Department for
Business, Energy
& Industrial Strategy

UK Offshore Energy Strategic Environmental Assessment

Consultation Feedback

UK Offshore Energy Strategic Environmental Assessment Future Leasing/Licensing for Offshore Renewable Energy, Offshore Oil & Gas and Gas Storage and Associated Infrastructure

Figure 5.81: Offshore wind: seafloor area remaining following application of “hard” constraints (10-60m) – refer to Table 5.35

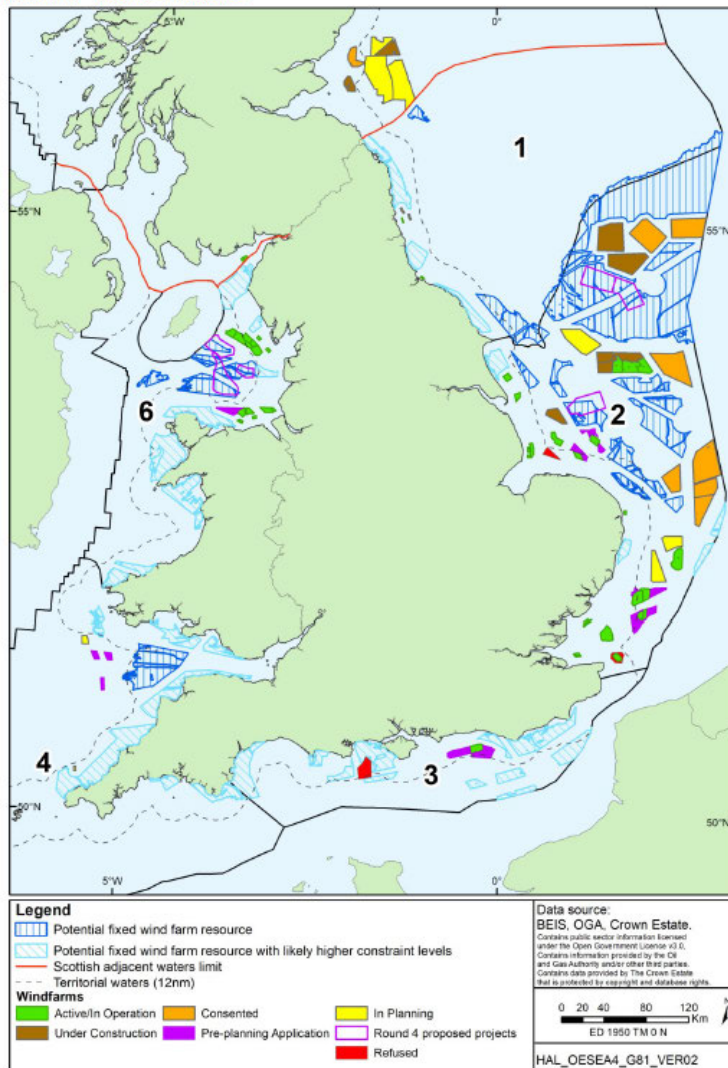
1. De ontwikkeling van vaste windmolenparken gebaseerd op een verscheidenheid aan beperkingen opgelegd zoals veiligheidszones rond infrastructuur, vaarroutes, visserij, mariene leidingen, mariene conservatie zone e.d.
 - a. Donkerblauw gearceerd: potentieel gebied voor de ontwikkeling van vaste windmolenparken
 - b. Lichtblauw gearceerd: potentieel gebied voor de ontwikkeling van vaste windmolenparken waar meer beperkingen kunnen opgelegd worden
 - c. Groen: actuele actieve windmolenparken
 - d. Oranje: goedgekeurd om te ontwikkelen, maar waar de ontwikkelaar wacht tot het economisch rendabel is (vraag naar hernieuwbare energie hoog genoeg)
 - e. Geel: ontwikkeling van windmolenparken in planning zijn
 - f. Bruin: windmolenparken in aanbouw
 - g. Paars: windmolenparken in pre-planningsfase of conceptfase
 - h. Rood: geweigerde windmolenparken

Figure 5.87: Offshore wind: seafloor area remaining following application of “hard” constraints (50-200m) – refer to Table 5.35

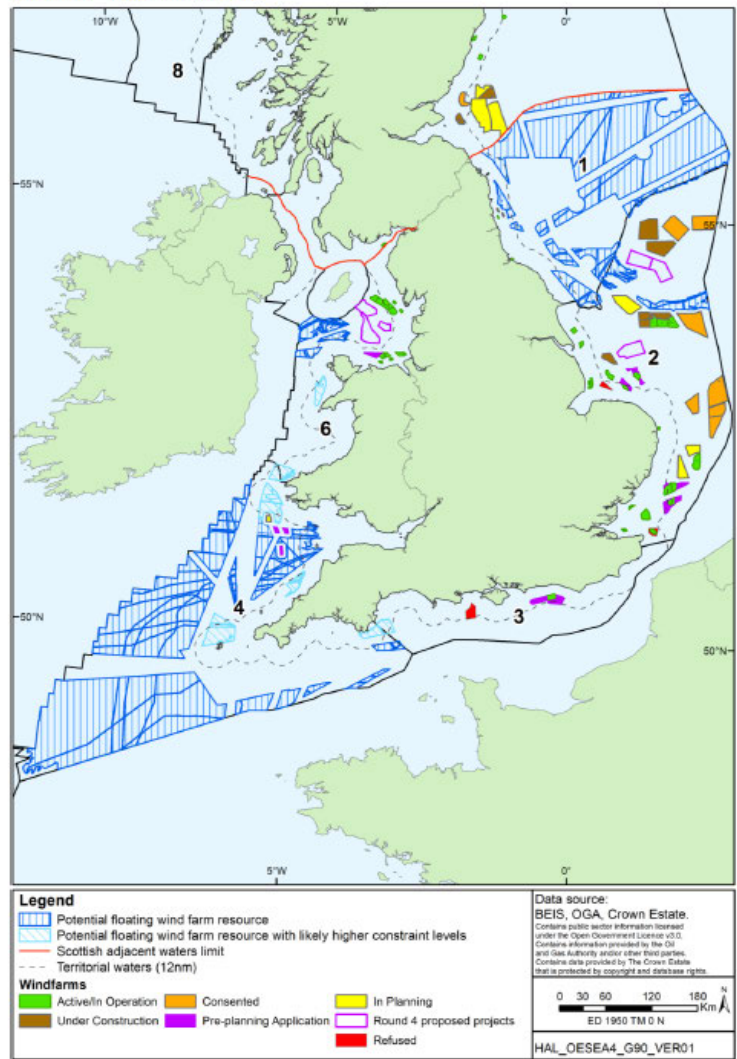
2. De ontwikkeling van drijvende windmolenparken gebaseerd op een verscheidenheid aan beperkingen opgelegd zoals veiligheidszones rond infrastructuur, vaarroutes, visserij, mariene leidingen, mariene conservatie zone e.d.:
 - a. Donkerblauw gearceerd: potentieel gebied voor de ontwikkeling van drijvende windmolenparken
 - b. Lichtblauw gearceerd: potentieel gebied voor de ontwikkeling van drijvende windmolenparken waar meer beperkingen kunnen opgelegd worden

Figure 5.92: Wave: seafloor area remaining following application of “hard” constraints

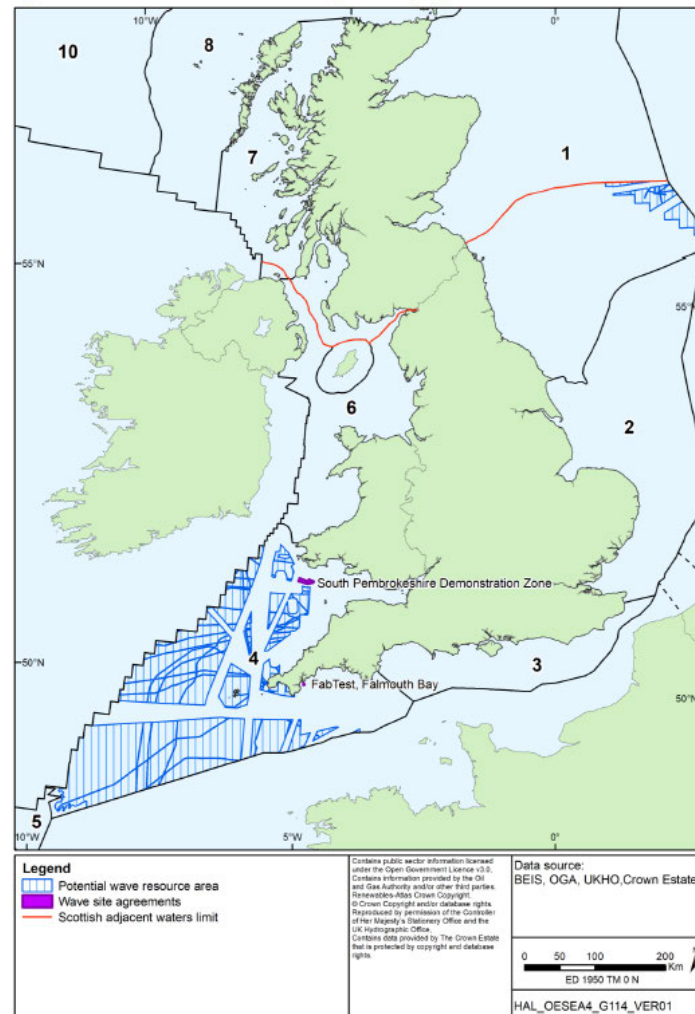
3. Golf- en getijdenenergie:
